Village of Arlington Heights
Plan Commission
Board Room
Arlington Heights Village Hall
33 S. Arlington Heights Road
Arlington Heights, IL 60005
February 24, 2016
7:30 PM

- A. 504 S. Mitchell Subdivision - PC#14-016
Preliminary Plat of Subdivision, Plat of Vacation
- B. Memory Care Facility - 511 W. Rand Rd. - PC#15-023
Rezoning, Comprehensive Plan Amendment, Preliminary PUD

To: Plan Commission
Prepared By: Bill Enright, Deputy Director Planning and Community Development
Meeting Date: February 24, 2016
Date Prepared: February 17, 2016
Project Title: 504 S. Mitchell: Bruscato Subdivision
Address: 504 S. Mitchell Avenue

To: Plan Commission
Prepared By: Bill Enright, Deputy Director Planning and Community Development
Meeting Date: February 24, 2016
Date Prepared: February 18, 2016
Project Title: Memory Care Facility
Address: 511 W. Rand Road

SHEET NO.
A1.0

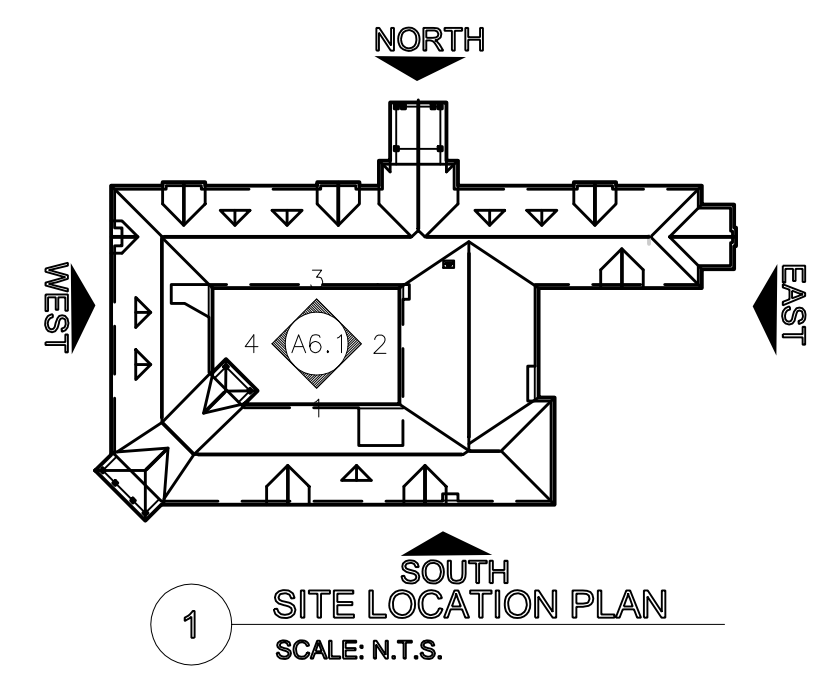
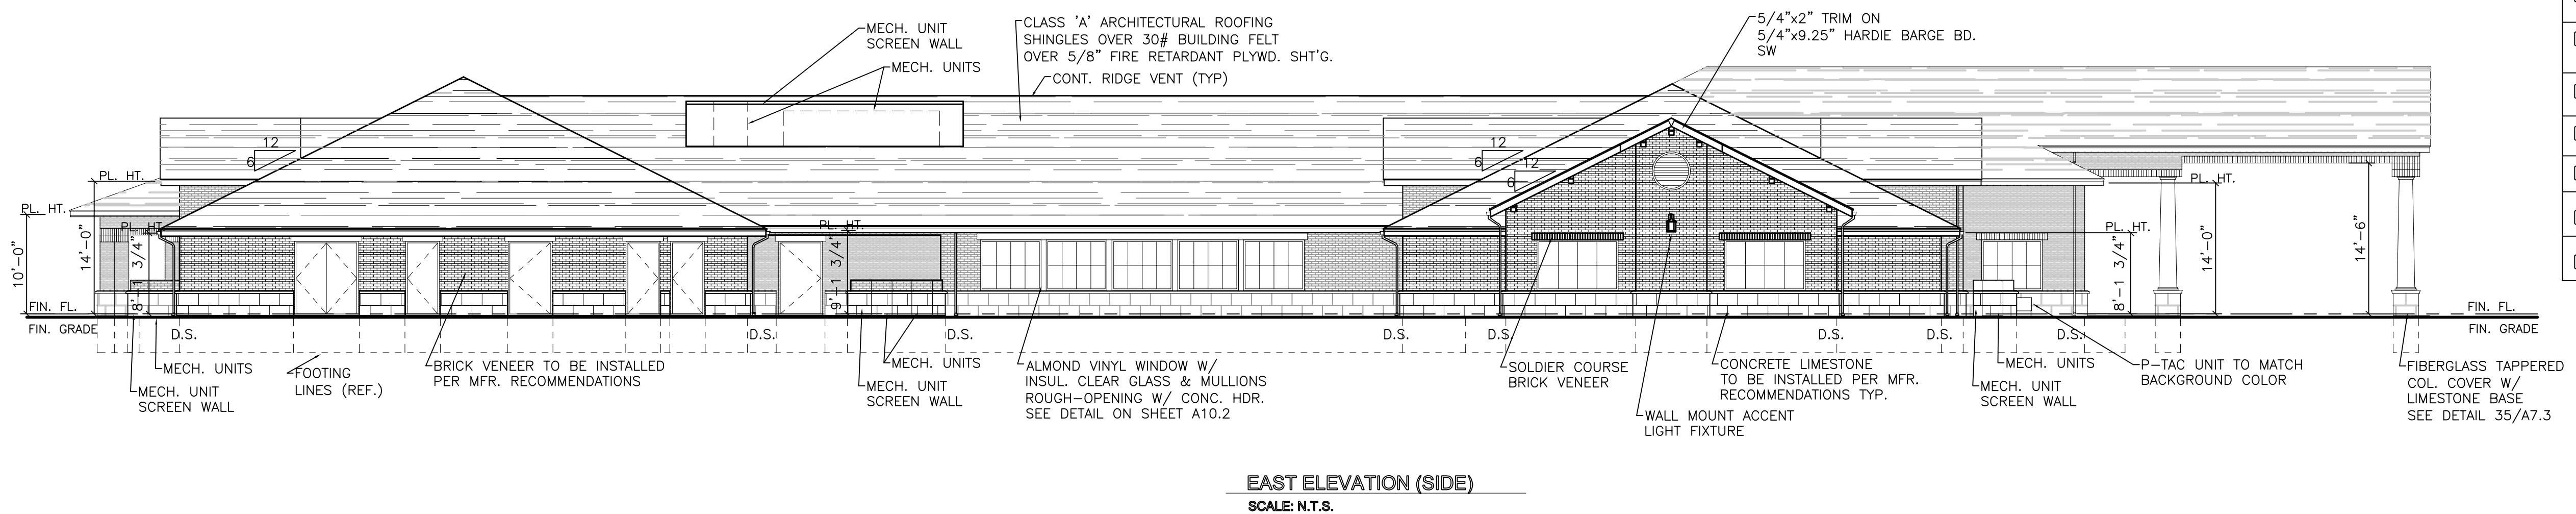
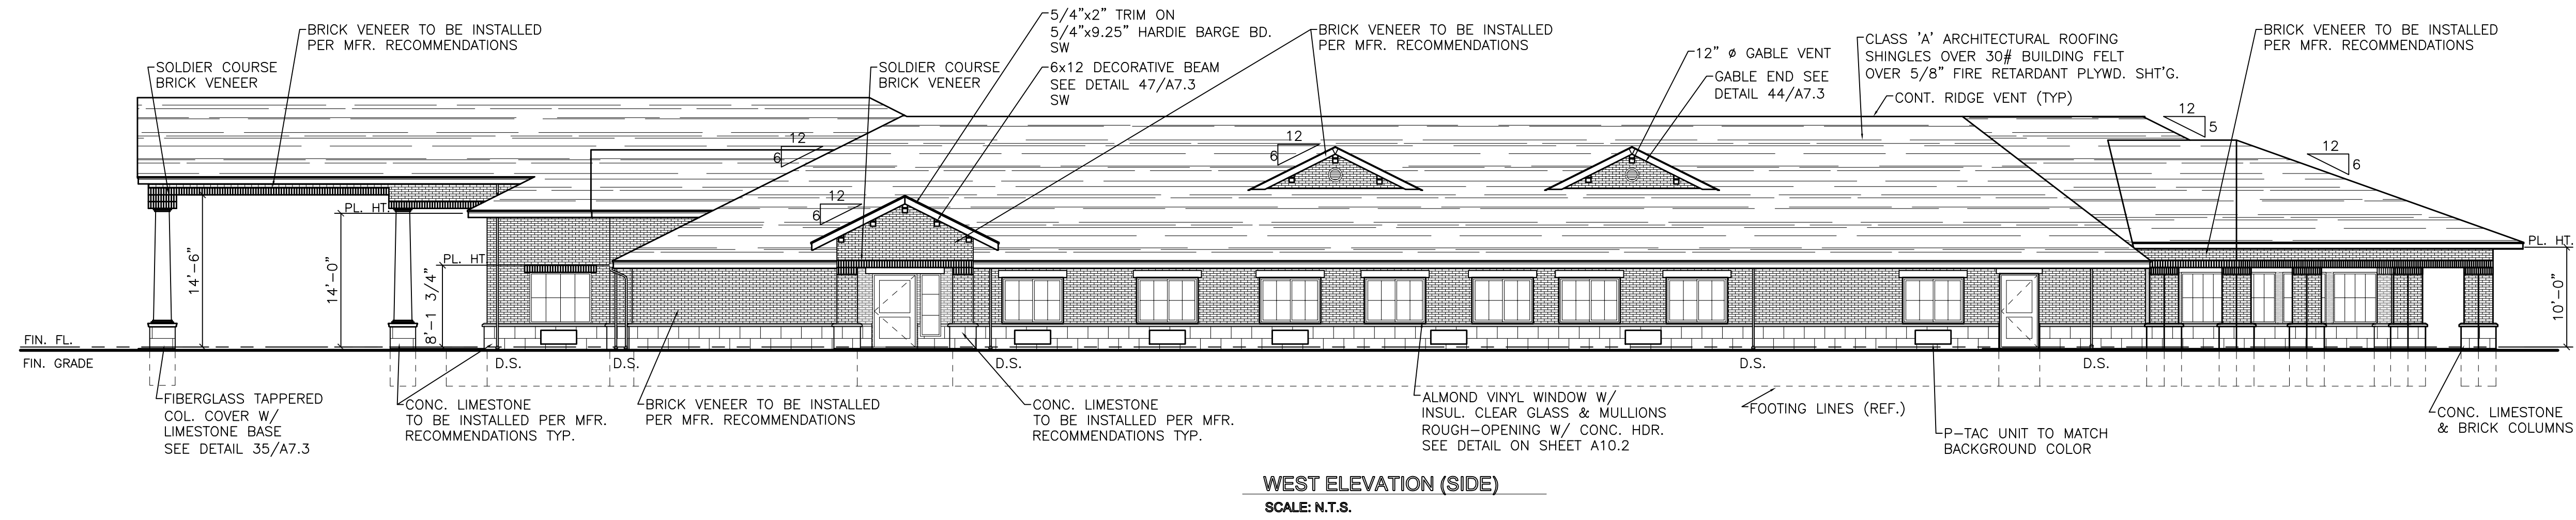
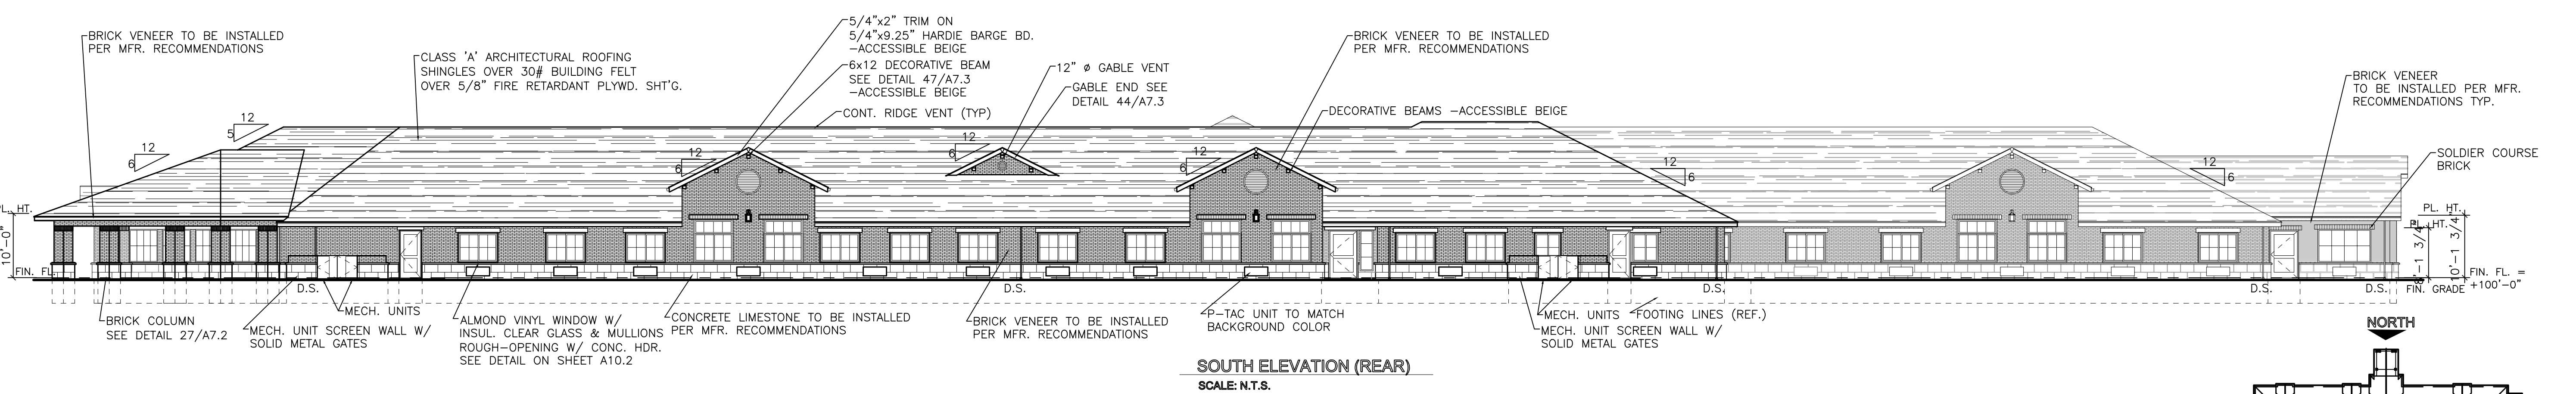
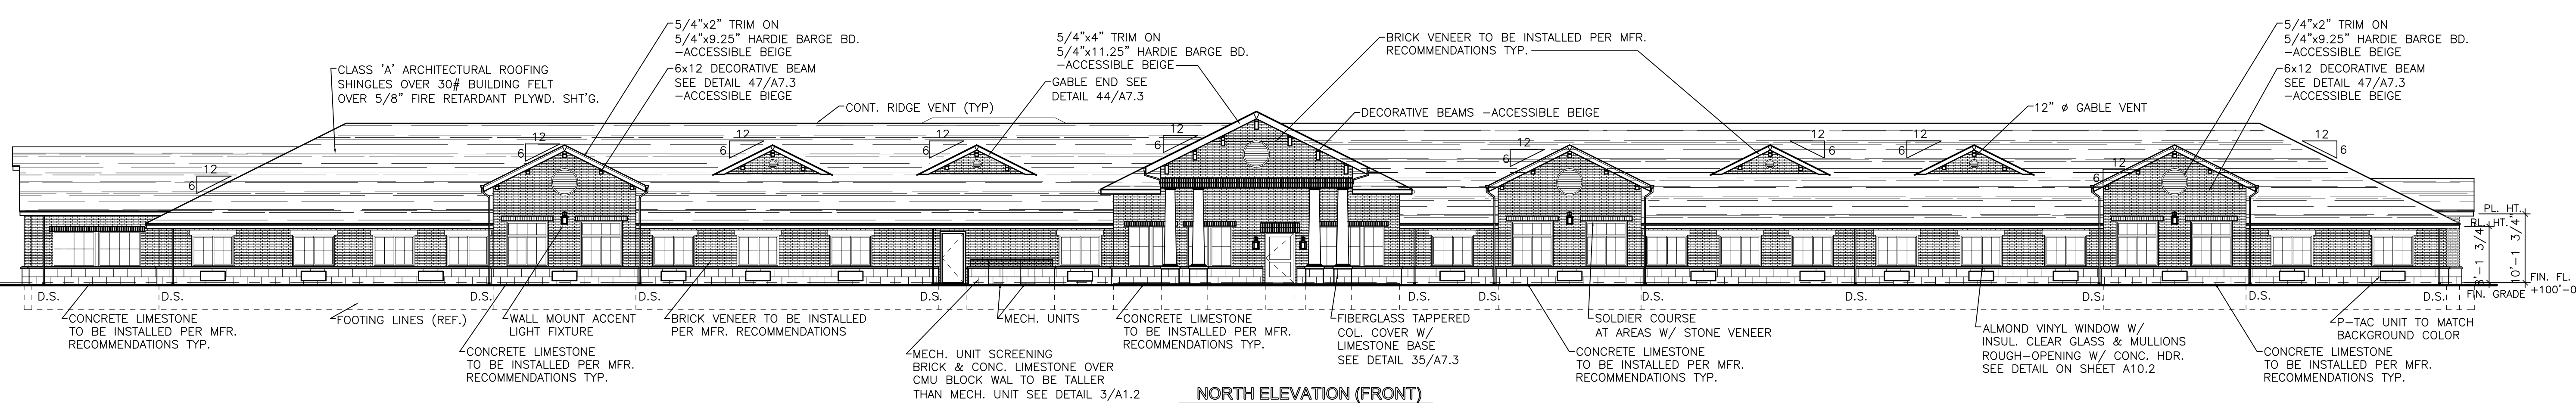
1. Please update the zoning Data on the Site Plan Sheet A1.0: the address is 511 W Rand Road; Proposed Zoning is Institutional; Proposed Use is Memory Care (Nursing Home) permitted in Institutional Zone; Parking Calculation is for Nursing Home not Human Services.

Sheet A1.0 has been revised to show updated zoning data, address, proposed use and parking requirements.
